To All Lamborghini Dealers and Licensed Service Point  
From Customer Service Department  
Subject Oil level dipstick & sticker  
Group LB824.01.17  
Attachments -  
Date 20/07/2007  
Pages 6

New oil level dipstick & sticker

MY 07 Murciélago LP640 (Coupè and Roadster) from VIN B71805 to VIN B72615.

Pict. 3 Sticker for the engine compartment 07M 115 562 B

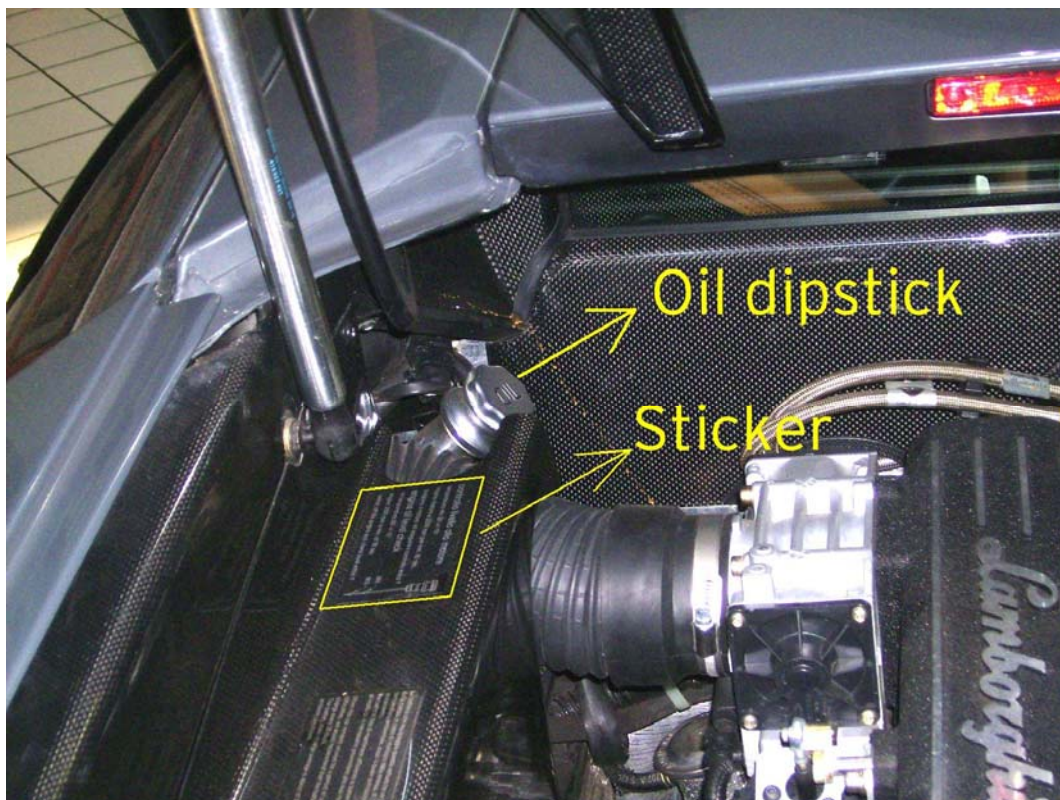
- One oil level dipstick (Picture 1 for Coupè and 2 for Roadster)
- One sticker for the engine compartment (Picture 3)
- One new page for the user manual (attachment at the end of this document)

- 1.1 Adopt all precautions to prevent car damages and to work safe.
- 1.2 Replace the old dipstick and the sticker as shown in picture 4 with the new ones. The dipstick code is written under the cap as shown in picture 5.
- 1.3 Add the corrective page for the User Manual booklet as indicated below:
  - pag. 135 for Coupè USA & Canadian market
  - pag. 105 for Coupè European and Rest of the World market
  - pag. 153 for Roadster USA & Canadian market
  - pag. 121 for Roadster European and Rest of the World market

check at oil temperature 80° +/- 10°C  
engine started since 5 minutes  
engine at idle 60 seconds  
switch off the engine and check level within 30 seconds
